**NOTIFICATION OF A PROPOSED CHANGE TO A PREVIOUSLY APPROVED  
DEVELOPMENT OF REGIONAL IMPACT (DRI)  
SUBSECTION 380.06(7), FLORIDA STATUTES**

A side-by-side comparison of the current Map H and the proposed Map H reflecting the proposed changes is included with this application as **Exhibit "B"**.

## Exhibit “B”

### Current and Proposed Map H Preliminary Concept Plan

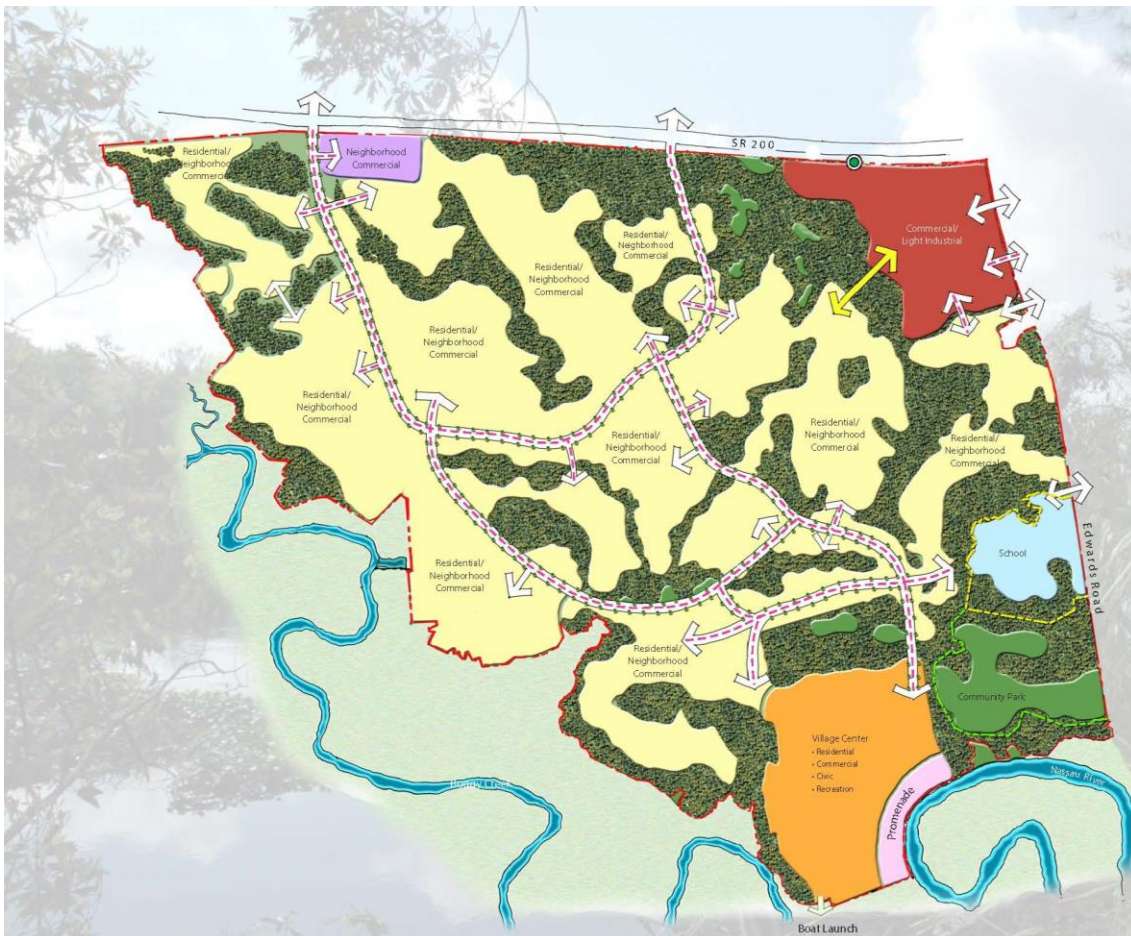
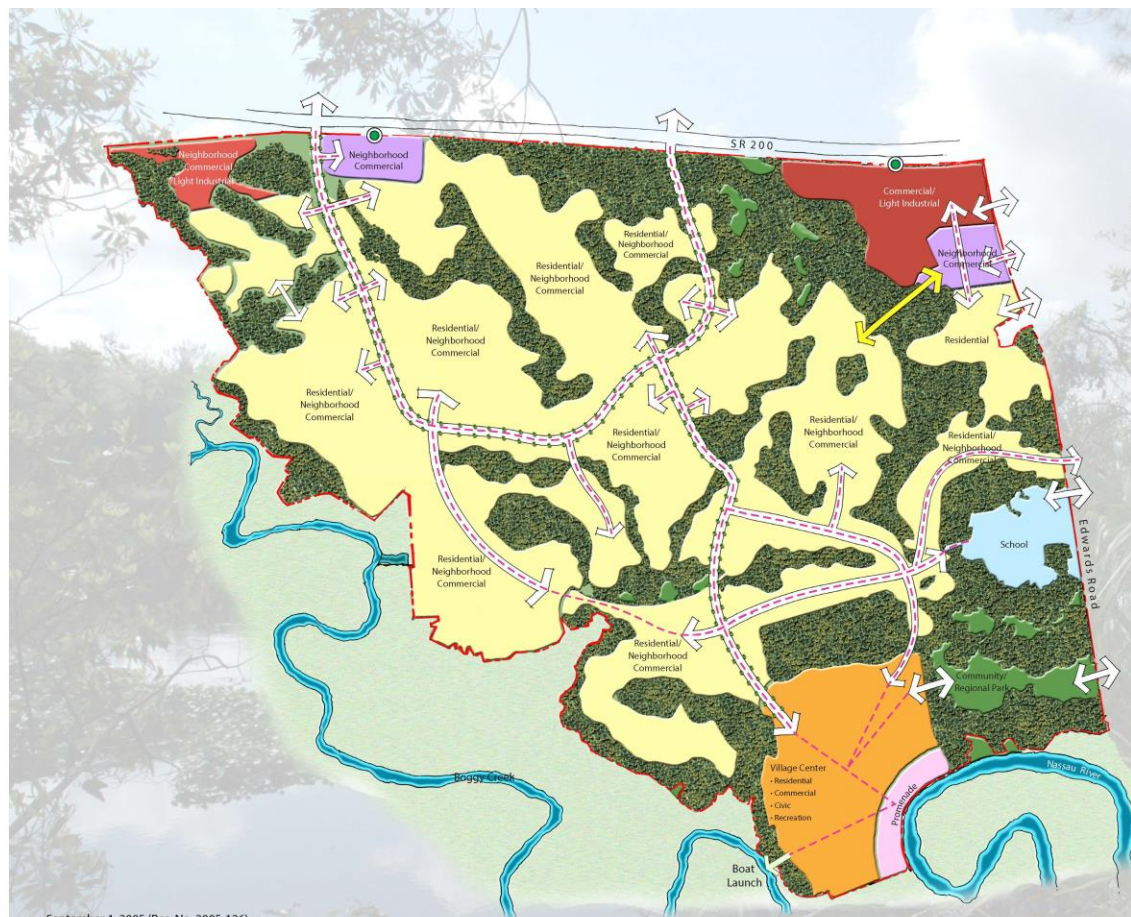
- (1) Change the Developer from Three Rivers Timber, LLC to Three Rivers Developers, LLC;*
- (2) Reflect statutory extensions pursuant to Section 252.363, Florida Statutes to phasing, build-out, termination, expiration, and downzoning protection dates.*
- (3) Revise Special Condition 27(a) to reflect a recent agreement with Nassau County regarding fire protection;*
- (4) Wholesale revisions to match current statutory and government citations and names that have changed since 2006; and*
- (5) Modify the Preliminary Concept Plan (Map H) to reflect the Developer's intended plan of development, specifically:*
  - Accurately illustrate ownership boundaries of the Commercial northeast corner, school site, and regional park;*
  - Shift the Village Center boat launch to the west;*
  - Allow the option for Light Industrial use at the northwest corner;*

- Add a potential right-in/right-out access to SR 200 from the Neighborhood Commercial pod;
- Add a Neighborhood Commercial pod adjacent to the Commercial/Light Industrial pod;
- Revise roadway network to show connection from easternmost Residential/Neighborhood Commercial pod to Edwards Road and to provide pedestrian connection (rather than vehicular connection) over wetland on westernmost road; and
- Shoe vehicular connections in Village Center.
